**ARMIDALE SECONDARY COLLEGE - NEW MULTI-PURPOSE HALL**

**BUILDING CODE OF AUSTRALIA VOL 1 2019  
FINAL CONCEPT DESIGN REVIEW**

**JUNE 2020**

Report prepared for	NBRS Architecture Level 3, 4 Glen Street, Milsons Point NSW 2061  Attention: Macella Salzmänn
Report prepared by	Metro Building Consultancy Suite 102, 12 Mount Street, North Sydney NSW 2060  Consultant: Sean Moore
Report reference	17194-ASC-BCAR07
Job number	17194
Date	19 <sup>th</sup> June 2020

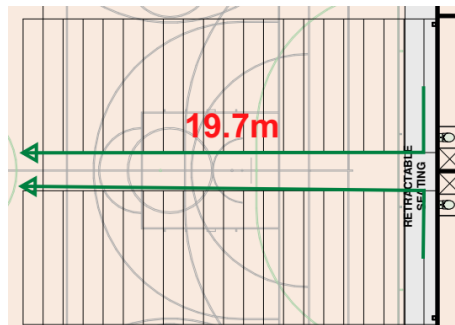
- Balustrades are not permitted to have an opening greater than 125mm.
- Electrical, comms or mechanical distribution boards installed along a path of travel to an exit are required to be enclosed by non-combustible construction or a fire protective covering with doorways or openings suitably sealed against smoke spreading from the enclosure.

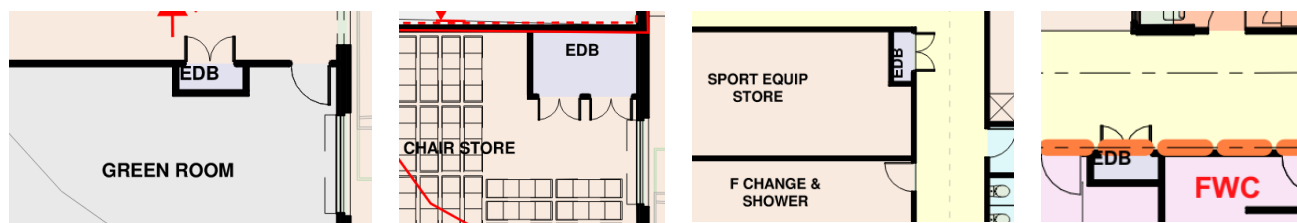
The path of travel from the discharge point of the proposed exits to the road must have an unobstructed width throughout of not less than 1m to a road or open space.

If an exit discharges to open space that is at a different level than the public road to which it is connected a path of travel to the road must be a ramp not steeper than 1:8 at any part or not steeper than 1:14 if required by required by part D3 of the BCA or a stairway complying with the deemed-to-satisfy provisions of the BCA.

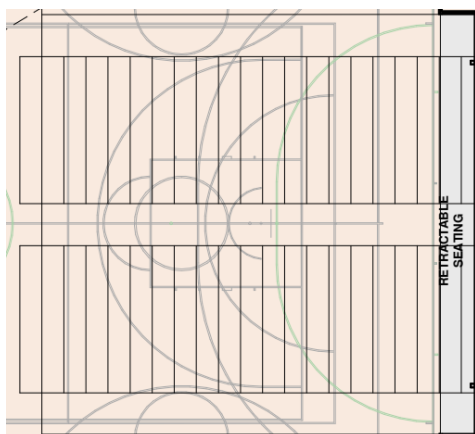
The proposed stairs are required to be provided with risers and goings that have a constant dimension throughout the flight and with a handrail with a height of 865-1000mm.

The BCA states that risers are not permitted to have any openings that would allow a 125mm sphere to pass through between the treads eg the retractable seating stairs.

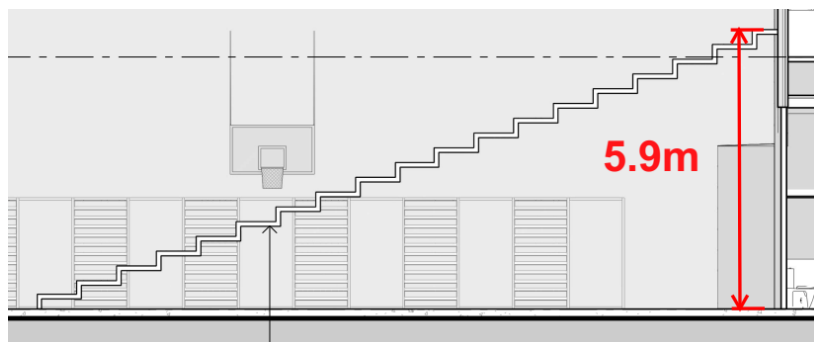
A balustrade with a minimum height of 865mm is required to be provided alongside landings to stairs or ramps that protect a drop of more than 1m and that have a length not exceeding 500mm. Where the landing length exceeds 500mm the balustrade is required to have a minimum height of 1m.

Balustrades are required in the following locations.

As the balustrades that protect the top of the retractable seating protect a fall of more than 4m the balustrade is not permitted to have any horizontal or near horizontal elements between 150 mm and 760 mm above the floor that facilitates climbing.

### Smoke hazard management – Stage

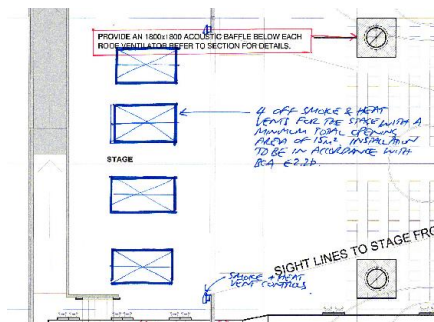
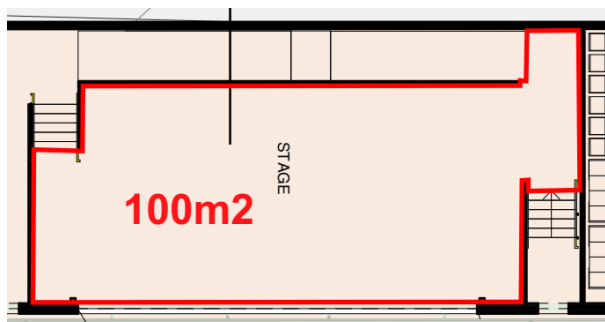
A building or part of a building used as an assembly building which has a stage with a floor area of more than 50 m<sup>2</sup> and not more than 150 m<sup>2</sup> must, over the stage, be provided with:

- an automatic smoke exhaust system complying with Specification E2.2b (including Figure 2); or
- roof mounted automatic smoke-and-heat vents complying with NSW H101.22 in a single storey building.

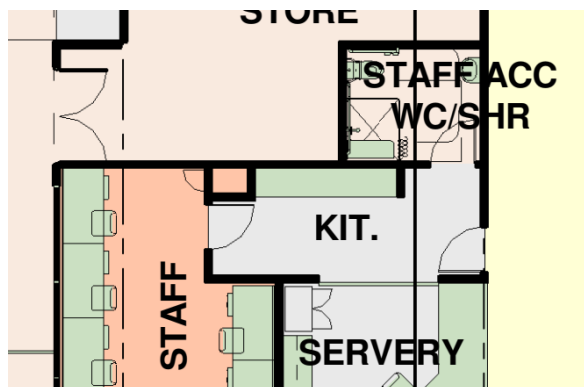
The BCA states that Class 9b theatres and sporting venues must be provided with one shower for each 10 participants or part thereof.

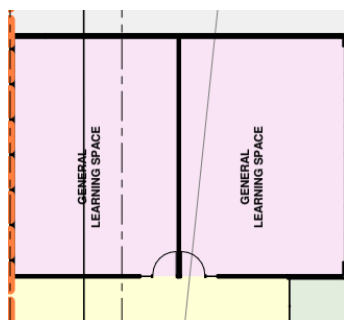
The BCA states that the ceiling height in a theatre, public hall or other assembly building or part that accommodates more than 100 persons must be not less than 2.7m.

The BCA states that all classrooms, offices and the kitchen are required to have a minimum ceiling height of 2.4m.
